Staff Report Z-SP-2-20-8 May 5, 2020

South Mountain Village Planning

Proposed Use: Mortuary and all underlying C-2 Uses

Location: Northwest Corner of 25th Street and Broadway

E. BROADWAY ROAD

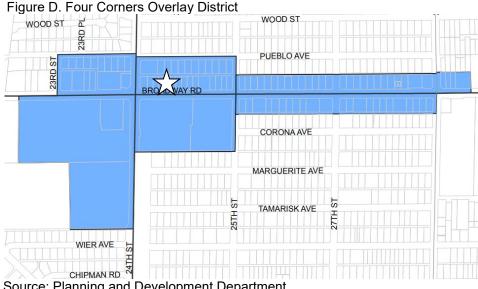
4. The applicant is proposing to repurpose an existing building into a mortuary with a new parking area located to the west.

The site plan proposes 25 parking spaces, bike racks, enhanced landscape treatments, enhanced sidewalks, and a serenity garden.

- 1. The sidewalk along Broadway Road shall be a minimum of 10-feet-wide and detached with a minimum 6-foot-wide landscape area between the sidewalk and the back of curb and a minimum 8-foot-wide landscape area on the north side of the sidewalk, planted with minimum 3-inch caliper single trunk shade trees planted a minimum of 20 feet on center or in equivalent groupings along both sides of the sidewalk, as approved by the Planning and Development Department.

- The sidewalk along 25th Street shall be detached with a minimum 5-foot-wide landscaped strip located between the sidewalk and back of curb and shall include minimum 3-inch caliper single trunk shade trees planted a minimum of 20 feet on center or in equivalent groupings along both sides of the sidewalk, as approved by the Planning and Development Department.

- 3. The bus stop pad on Broadway Road and the detached sidewalks on both 25th Street and Broadway Road shall be shaded a minimum of 50 percent using shade trees, as approved by the Planning and Development Department.

- 5. The developer shall plant shade trees in and around the parking area to provide shade for 50 percent of the parking area, as approved by the Planning and Development Department.
